DRAFT TECHNICAL REVIEW REPORT OF THE LUANG PRABANG HYDROPOWER PROJECT – SEDIMENT TRANSPORT AND GEOMORPHOLOGY

DAY 1: THE 2ND REGIONAL INFORMATION SHARING ON PRIOR CONSULTATION FOR LUANG PRABANG
HYDROPOWER PROJECT

05 FEBRUARY 2020, LUANG PRABANG, LAO PDR

Trend Analysis of Annual Suspended Sediment Concentration at Chiang Saen Station – 40-years data provided by the Thai Department of Water Resources

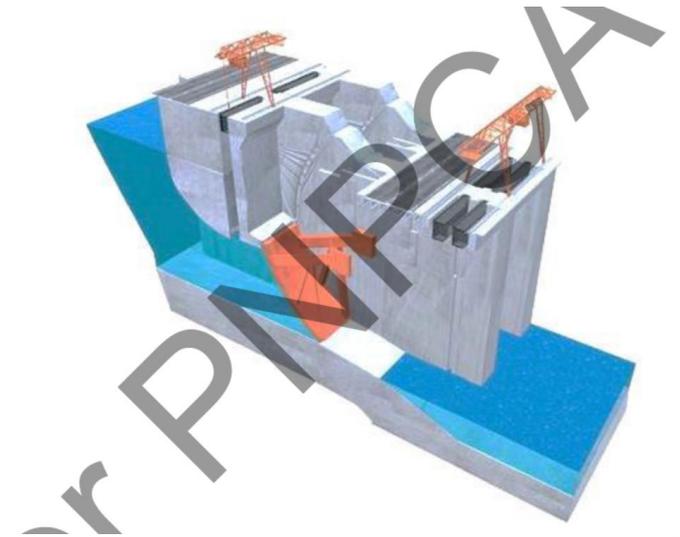
- The developer should use **available information** related to sediment transport modelling including sediment trapping in impoundments under various **MRC studies** which provide basin-wide context in literature review.
- The conditions at the LPHPP are not accurately captured by the Chiang Saen and Luang Prabang monitoring sites due to **contribution from Nam Ou river and tributaries**. **No site-specific data was collected** to verify this assumption.
- **No site-specific grain-size information** was provided which was shown to be very important for sediment trapping.
- Need further information and discussion on **impacts of combined operations** of Nam Ou, Xayaburi and LP HPP.

Main Review Findings (5) – Sediment Transport Modeling

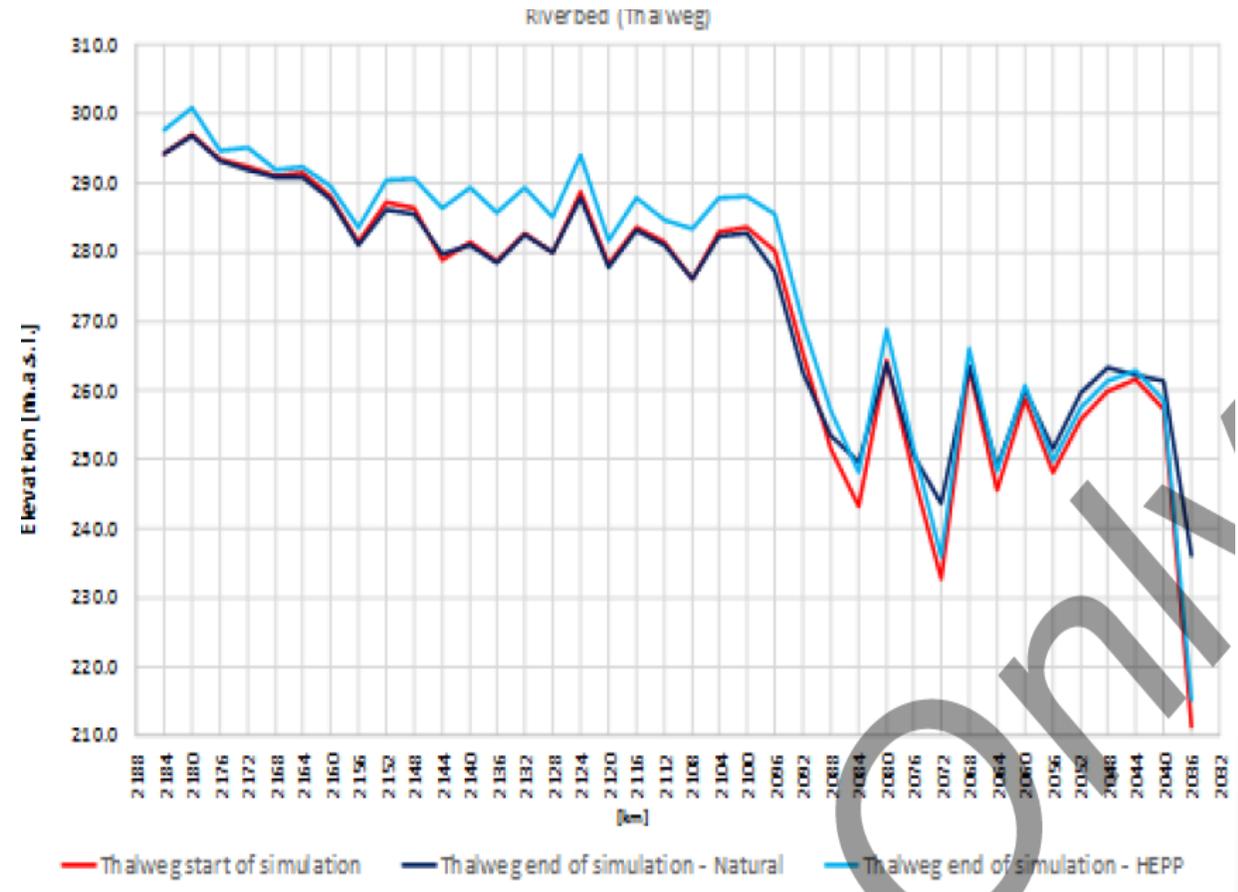
- The model results show **deposition throughout the impounded area**, with higher potential in the area between km 2052 and 2164.
- There is no sediment transport modelling associated with **sediment discharge from the dam** related to the proposed use of the LLO, sediment behaviour near the hydropower infrastructure, or downstream.
